Consolidation of the LHC SC magnets and circuits during LS1

Second LHC Splices Review (Nov 2011)

8th of February 2012

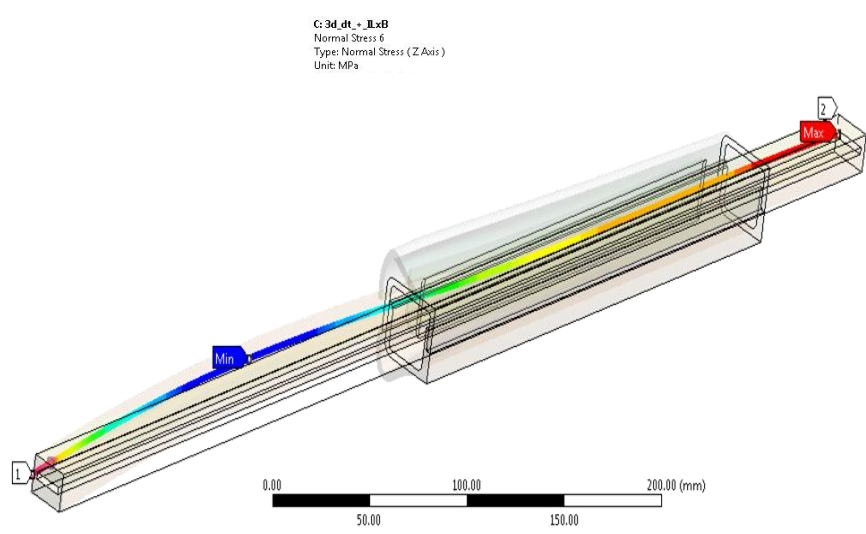
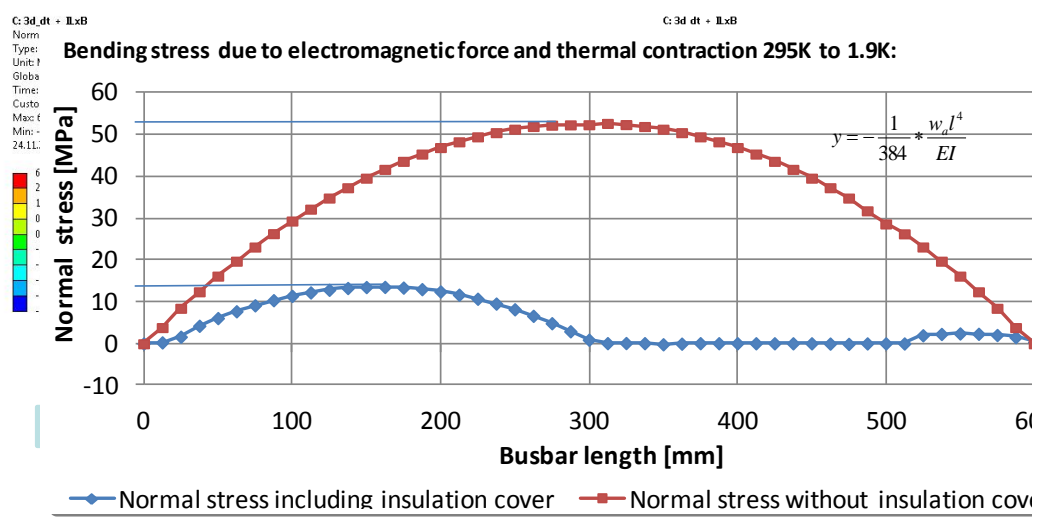
Insulation cover was to be finalised at the time of the review, now, **final concept is available**

“This is a clever design which provides the required functionality in the presence of non-negligible splice-to-splice dimensional variations. However, the precise implementation of this scheme still needs to be developed”

- ❑ The insulation cover must be adequate to reduce the mechanical stresses on the splices and the shunts so that they do not degrade over time.
- ❑ Modeling of shunt insulation cover is not yet sufficient to show that it is effective as a mechanical constraint, and we have doubts that the existing cover design is adequate.

The safe operating current as a function of the defect length of the shunt solder

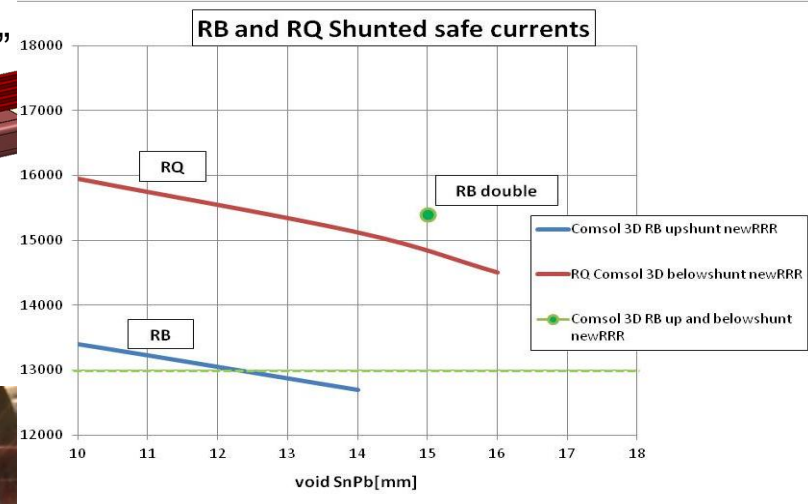
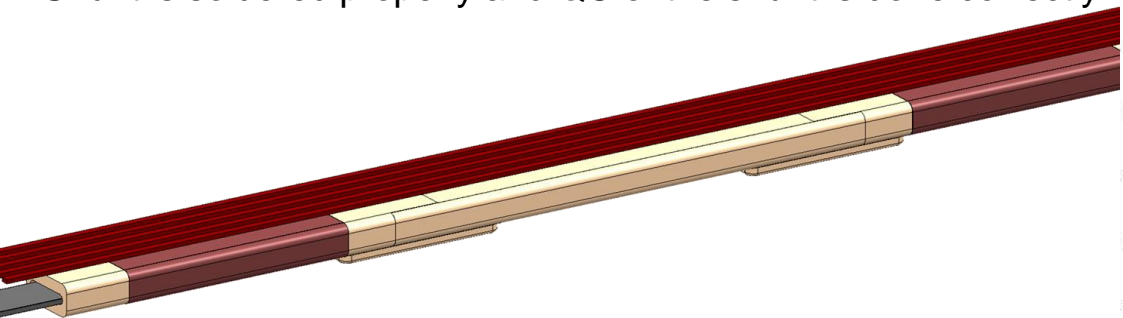
5. The endorsement of installing a **single shunt on the RQ BB** is conditioned to compensatory measures:

Rev 1 Rec 3.1: "The Committee recommends that a double shunt be applied to the quad bus"

Rev 2: Rec 1) "If a single shunt is to be used on the quadrupole bus, then the following must be met:

- The "rebuilt" criteria are met
- Clamp is effective in limiting the deflection and stress on splice, to prevent future degradation of the copper stabilizer connection
- Energy extraction time constant is reduced to ≤ 20 sec
- Shunt is soldered properly and QC of the shunt is done correctly"

SHM to HCM connection

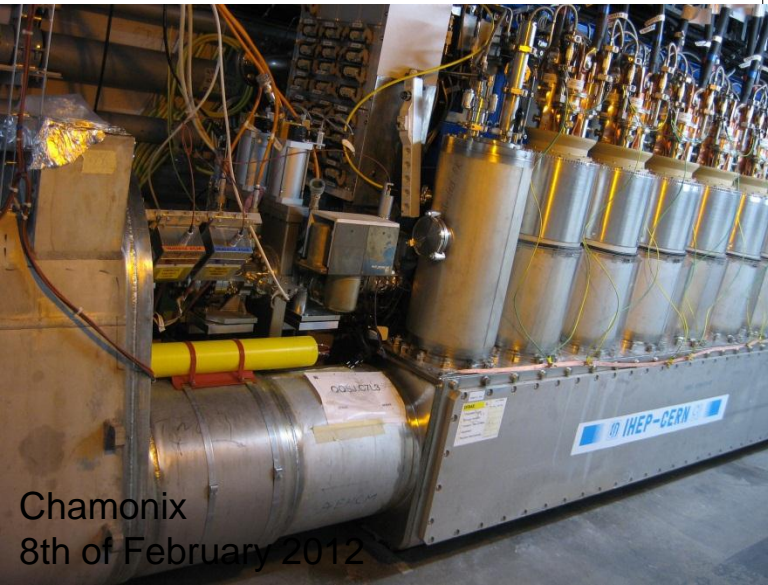
For the 16 DFBA, a first analysis shows that the splices in 14 of them can be consolidated "in situ". SHM-HCM splices of **two DFBA**s (1 in DFBA P and 6 in DFBA K) **cannot be accessed "in situ" for consolidation.**
